**SITE:** Land at Three Elms, North East Quarter To the north east of Huntington and bounded by Three Elms Road and Roman Road, Hereford, Herefordshire HR4 7RA

**DESCRIPTION:** Outline Planning application with all matters reserved, except access, for the first phase of an urban extension comprising up to 350 homes (Use Class C3); park & choose interchange; together with open and play space, landscaping, infrastructure and associated works.

**APPLICATION NO:** 222138

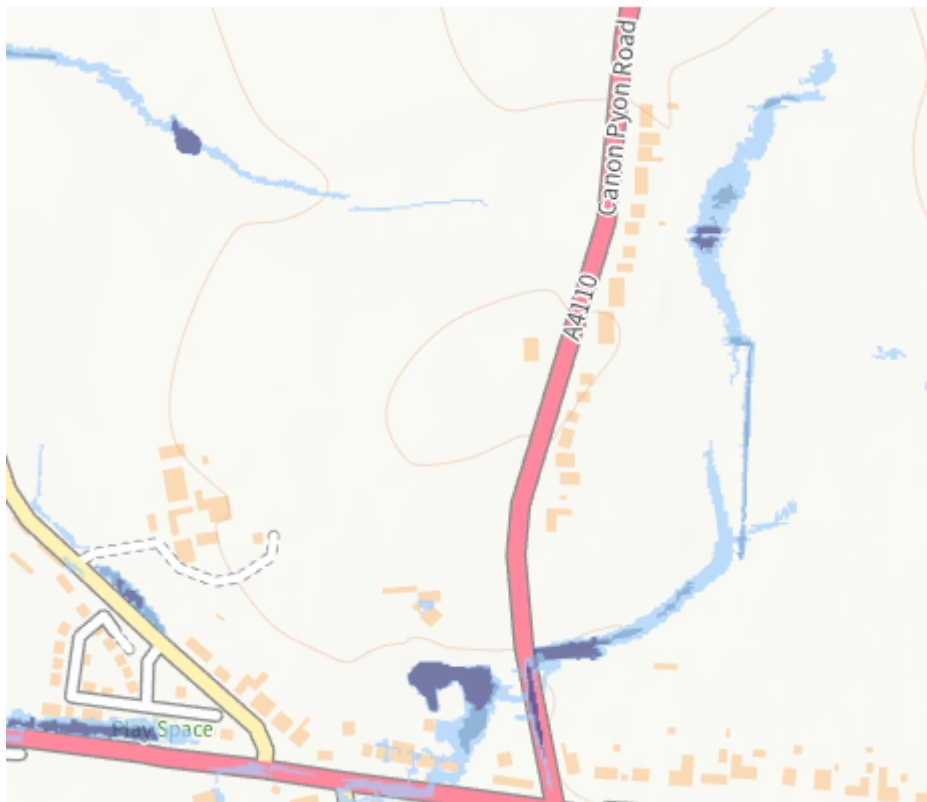
The surface water strategies for Tillington Road and The Paddocks were reviewed and approved prior to construction, runoff **rates** for both sites were gently inflated owing to blockage risks (runoff rates would have sharply increased if the flow controls were to block). We see no reason for further analysis of the discharges from these sites because the runoff **volumes** have not significantly increased.

The Livestock Market was constructed around 15 years ago when SuDS guidance was less developed. The applicant has queried whether the SuDS were installed correctly. Whilst the site is quite large, it is not on the banks of the Yazor Brook, moreover there are other impermeable areas upstream such as the Credenhill MOD base. We request that the applicant advises how impermeable areas within the catchment were modelled and provides commentary and technical justification for the runoff that may occur from these sources. As there is an absence of design information, runoff **rates** and **volumes** from the Livestock Market may be assumed to be increased.

7.11.2023 The applicant has provided commentary (23.10.2023) as follows. It is recognised that modelling techniques rely on the adoption of parameters that are selected to define the catchment using a coarse approach, which makes simulation of fine detail impractical (e.g. localised impermeable areas).

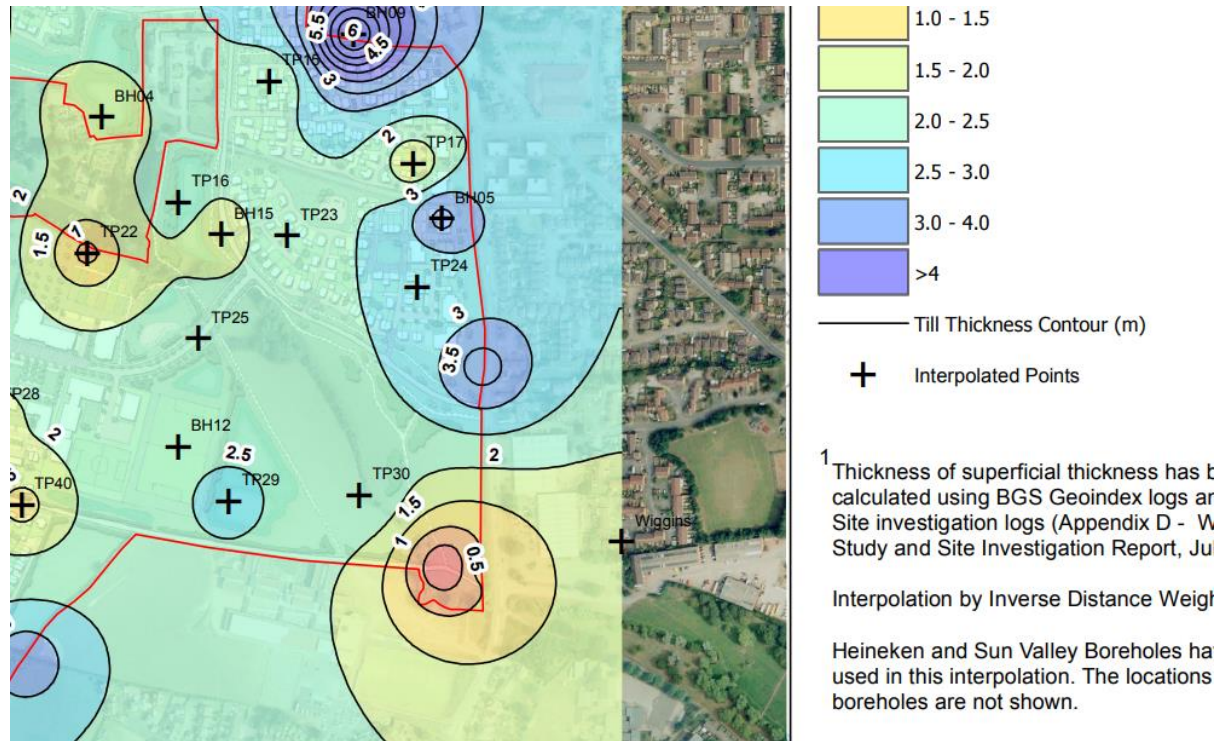
There is a risk that the A4110 (Three Ellms Road) culvert could become subjected to a partial blockage. An assessment is required to demonstrate the impact of a 50% blockage in the event of a 100 year + 37% climate change storm.

The FRA supporting application 162690 addendum included hydraulic modelling of the Yazor Brook to assess the benefits of on-site fluvial storage and to ensure that the works (and scheme as a whole) do not increase flood risk outside of the site boundary. Under more recent dialogue with the EA the concept of lowering ground levels in SPZ1 has been rejected.

7.11.2023 The 50% blockage scenario could be addressed at Reserved Matters stage.

13.8.2023 The applicant has presented proposals for ground lowering within R04 that would mobilise a maximum of 1500m<sup>3</sup> flood storage. Figure 7.2 in the modelling report shows that this would be installed on the eastern side of the Yazor Brook. The SPZ extents could however alter on receipt of the forthcoming groundwater modelled SPZ extents. This may make it possible to increase the size of the flood storage area. The modelling results do not show a tangible benefit and so re-sizing of the storage area would be encouraged after the SPZ extents are known

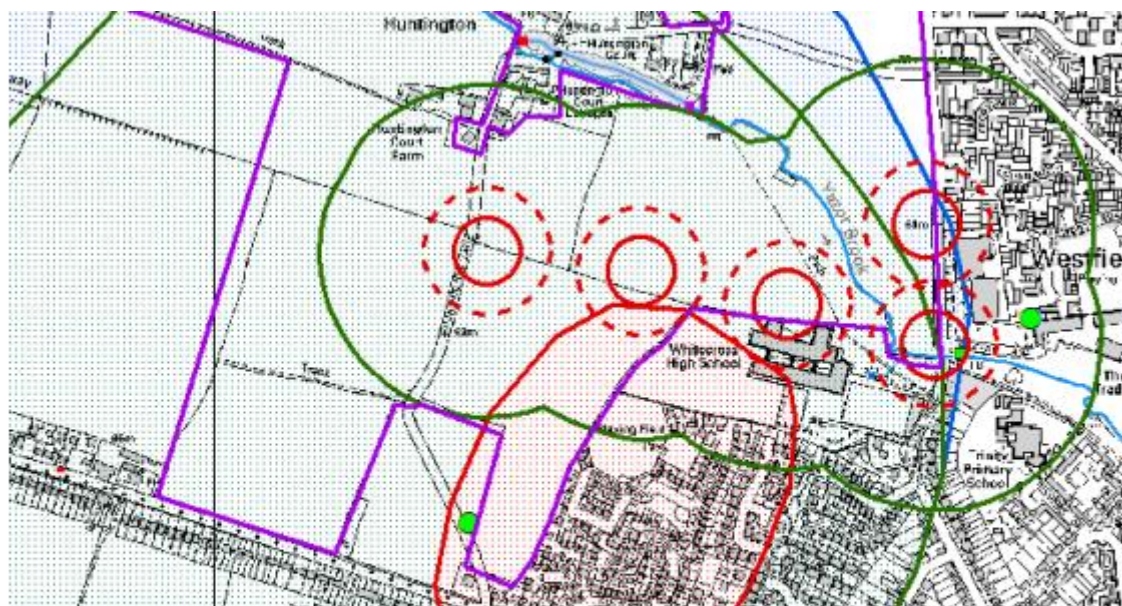
The applicant has advised that the EA requirements on Till depth can be achieved. We assume that the information submitted is both genuine and representative of site conditions so treat this advice in good faith.

The Environment Agency have commented on the depth of Till thickness as follows (email 6.11.2023)

“Based on the previous site investigation results the Till thickness in this area is estimated at around 2.0-2.5m (green), which is not particularly substantial. “

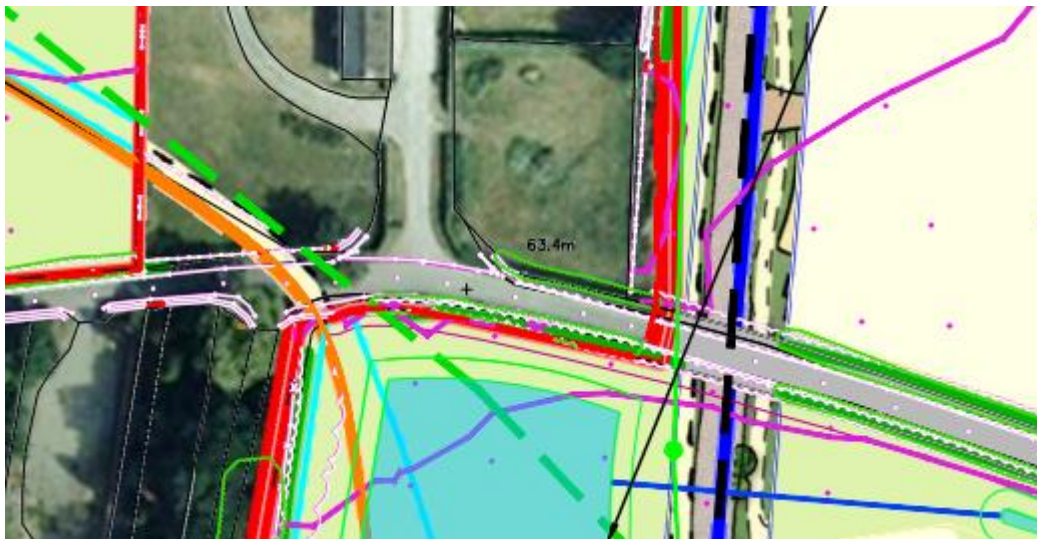
The revised drawing shows a short highway culvert installed between the proposed swale and the ditch. The applicant will need to consider the depth of any ditch and the size of this culvert, noting the requirements of the Culvert Design Guide. The 100 year + Climate change design flow needs to be established to confirm flow capacity requirements are met. Security screens present a risk of blockage and so should be designed out. If a short section of culvert is proposed, then it may be

possible to avoid installing security screens at both the inlet and outlet, by following the respective design guidance. Through careful design it may be possible to eliminate the need for such screens. Twin culverts are not preferred as one culvert will tend to block. Further clarity on these proposals is needed.
